# ARCHITECTURAL REVIEW BOARD STAFF REPORT

Project #/Name	ARB-2023-116: Three Notch'd Center
Review Type	Preliminary Architecture Review
Parcel Identification	056A3-00-00-00900
Location	5368 and 5370 Three Notch'd Rd. (Fig. 1)
Zoned	Planned Development Shopping Center (PDSC), Entrance Corridor (EC), Managed Steep Slopes
Owner/Applicant	Notch'd LLC/Design Develop LLC (Kevin Schafer)
Magisterial District	White Hall
Proposal	To construct a 23,120sf two-story multi-tenant building on a 2.32ac site that will be shared with an existing car wash building. The footprint of the multi-tenant building is 16,300sf with 6,820sf available in upper floors.
Context	The site is currently comprised of two buildings. A multi-tenant concrete block building is located near the EC, set back approximately 34 feet from the right-of-way (ROW), and will be replaced by the proposed building. The second building is a 1½-story carwash, located in the northwest corner of the parcel approximately 158 feet from the EC. It has brick at the first story, tan gable-end siding above, a brown shingled roof, and white trim. The two buildings currently operate independently, with separate parking lots and entrances.

Figure 2: Previously approved elevations for Three Notch'd Center

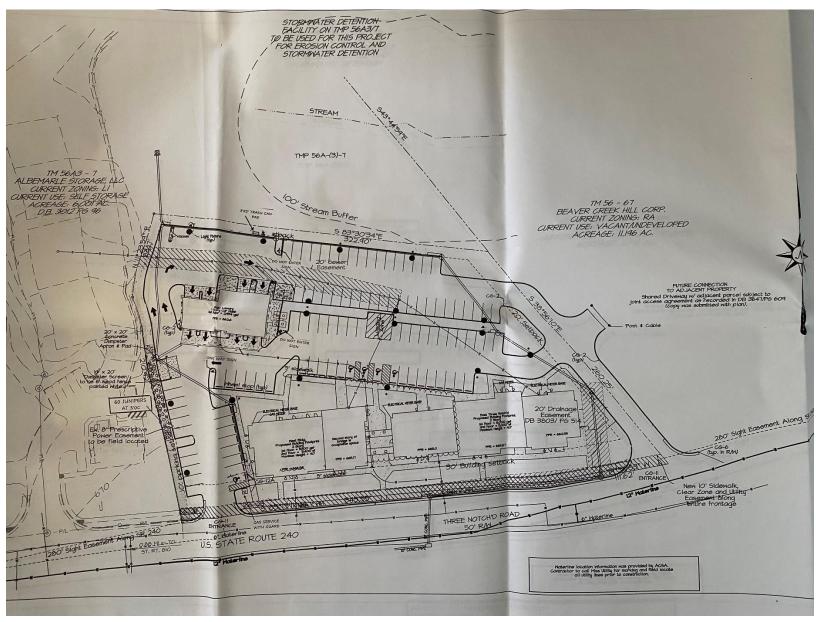
The planning and zoning history on this site is extensive. In 2009, the ARB approved a design for a commercial building in the location of the current proposal. See Figure 2 below for the approved design. Architectural designs for the carwash building were reviewed and approved by the ARB in 2013. That building was constructed in 2018.
